Product Change Notification (PCN)

PCN Number: PCN_WPME-FISM_1_20260831 Affected Series: WPME-FISM Affected Part Number: see table "PART NUMBER, REVISION & DATASHEET" PCN Date: 2026-05-31 (YYYY-MM-DD) Effective Date: 2026-08-31 (YYYY-MM-DD)	Change Category: ☐ Equipment/Location ☒ General Data ☐ Material ☐ Process ☐ Product Design ☐ Shipping/Packaging ☐ Supplier ☐ Software
Contact: Product Management Phone: +49 (0) 7942 - 945 5001 Fax: +49 (0) 7942 - 945 5179 E-Mail: pcn.eisos@we-online.com	Datasheet Change: ☒ Yes ☐ No Attachment: ☐ Yes ☒ No

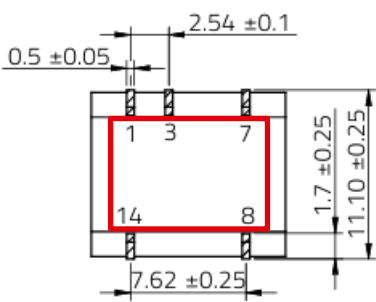
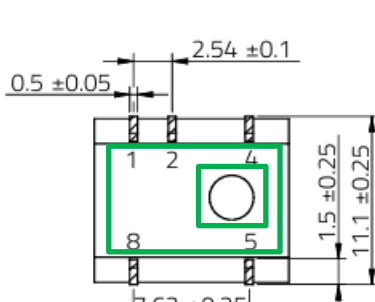
The pinout drawing has been corrected.

Before change	After change
 Pinout diagram showing 8 pins. Pin 14 is at the top left, pin 8 at the top right. Pin 1 is at the bottom left, pin 3 at the bottom center, pin 7 at the bottom right. Labels: NC (top left), +VOUT (top right), -VIN (bottom left), +VIN (bottom center), -VOUT (bottom right).	 Pinout diagram showing 8 pins. Pin 8 is at the top left, pin 5 at the top right. Pin 1 is at the bottom left, pin 2 at the bottom center, pin 4 at the bottom right. Labels: NC (top left), +VOUT (top right), -VIN (bottom left), +VIN (bottom center), -VOUT (bottom right).

The existing hole on the bottom of the module has been added to the drawing and the pin numbers are corrected.

Before change	After change
 Mechanical drawing showing dimensions: 0.5 ±0.05, 2.54 ±0.1, 7.62 ±0.25, 11.10 ±0.25, 1.7 ±0.25. Pin numbers 1, 3, 7, 14, 8 are shown.	 Mechanical drawing showing dimensions: 0.5 ±0.05, 2.54 ±0.1, 7.62 ±0.25, 11.1 ±0.25, 1.5 ±0.25. Pin numbers 1, 2, 4, 8, 5 are shown. A circular hole is added to the bottom center.
